REQUEST FOR INFORMATION FORM

Project No.:	01-26-020 (26766)	RFI No.:	RFI-126020-011
Date:	August 25, 2026	Discipline:	Mechanical
Project Name:	26766 – BA2107 TLE End-of-Life Replacement

Subject:	TLE Channel Cover Lifting Lugs
Specifications/Documents/Drawings Referenced or Impacted:	
26766 - CWP-G02 Rev 0.1 - 2021489 – IFC, Scope of Work Section 6.1.9	
Lifting Lug Drawing EA2102D-049 Rev 0.2, “EA-2102D New Lifting Lug Installation” (Work Package, page 92)

EA-2102D
NEW LIFTING LUG INSTALLATION

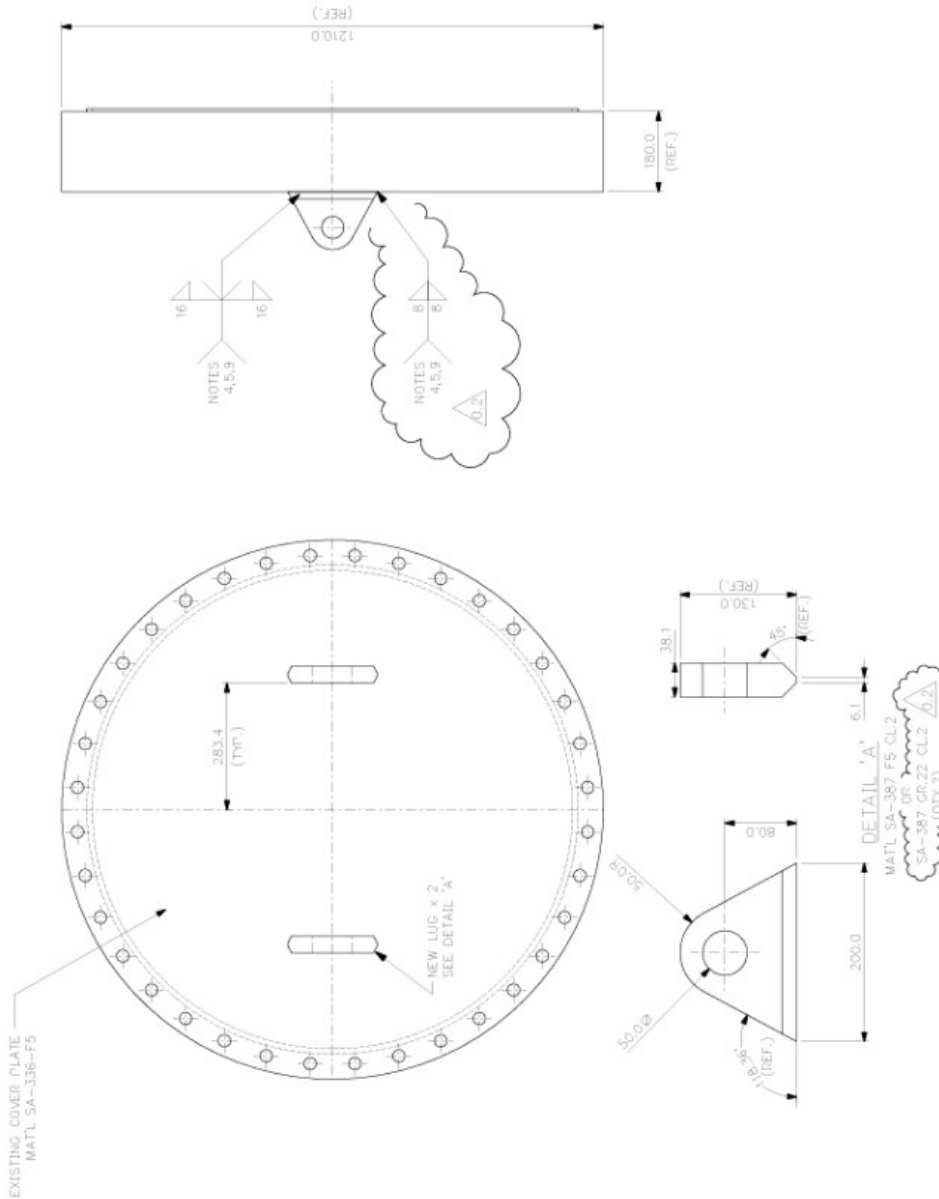
Question or Description of Issue:
Section 6.1.9 of the Construction Work Package directs the contractor to use the existing channel cover lifting lugs to remove TLEs EA-2107A, B and C. Specifically, it states: <i>“Use the existing lifting lug on the top of each TLE’s channel cover to lift existing TLEs tag # EA-2107A, B & C from heater BA-2107. Refer to drawing number EA2102D-049. The cover lifting lugs have a combined vertical lifting capacity of 43,042 lbs. These cover lifting lugs were installed on EA-2107A & B in 2022. One of these covers can be used to replace the cover on EA-2107C after EA-2107A&B have been removed.”</i> Drawing EA2102D-049 Rev. 0.2 indicates that the revised lifting lug arrangement was implemented on the EA-2107B channel in 2022; however, the lifting lug configuration shown on the drawing does not appear to be present in the field. The drawing notes: <i>“This change is implemented in April 2022, when EA-2102D channel is installed on EA-2107B TLE tube section. These lifting lugs have been designed for this configuration only. Any future change must be re-evaluated by engineering.”</i>

Originator’s Recommended Solution:
Please perform a field review to document the existing lifting lug configurations and provide direction on the appropriate lifting points and removal method for the existing TLEs.
Urgency: Medium (3 days)
Originator:
Nitin Joshi Name Signature PC Title August 25, 2026 Date
